April 29, 1983
L-83-271

Re: St. Lucie Unit 1
Docket No. 50-335
Relief Request from Technical Specification
Inservice Inspection Requirements

St. Lucie Unit #1
Inservice Inspection

"TYPICAL CONFIGURATION"

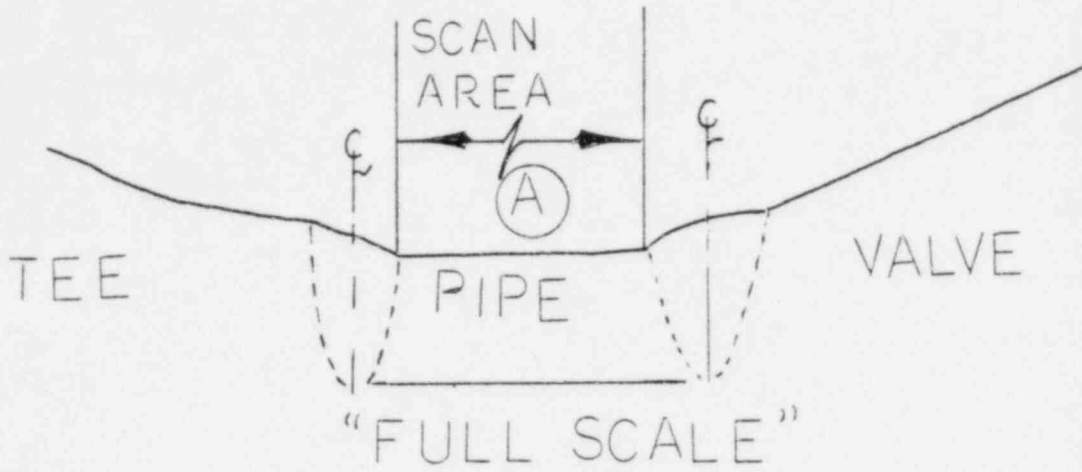
FPL opts to conduct Surface Examinations in lieu of Volumetric Examinations of the piping circumferential welds and base metal beyond the edge of the welds within the limitations of existing configurations for Examination Category B-J (Item B4.5). See attached sketch of "Typical Configuration".

1. Volumetric Examinations of the piping circumferential welds and base metal beyond the edge of the welds are found to be impractical. Because of the design and configuration, these welds are not conducive to Ultrasonic Examination and do not lend themselves to good Radiographic Examination technique.
2. The code (Examination Category B-J, Item B4.7) permits Surface Examination of Branch Pipe Connection welds six (6) inch diameter and smaller. This is somewhat typical and consistent with the pipe to tee welds which are six (6) inch nominal pipe diameter (see attached sketch).
3. Conduct of the Volumetric Examinations to meet the code would constitute undue hardship and unusual difficulty without a compensatory increase in the level of quality and safety.

Perform Surface Examinations on the piping circumferential welds and base metal beyond the edge of the welds within the limitations of existing configurations for Examination Category B-J (Item B4.5).

The examinations shall cover 25% of the circumferential joints during each Inspection Interval.
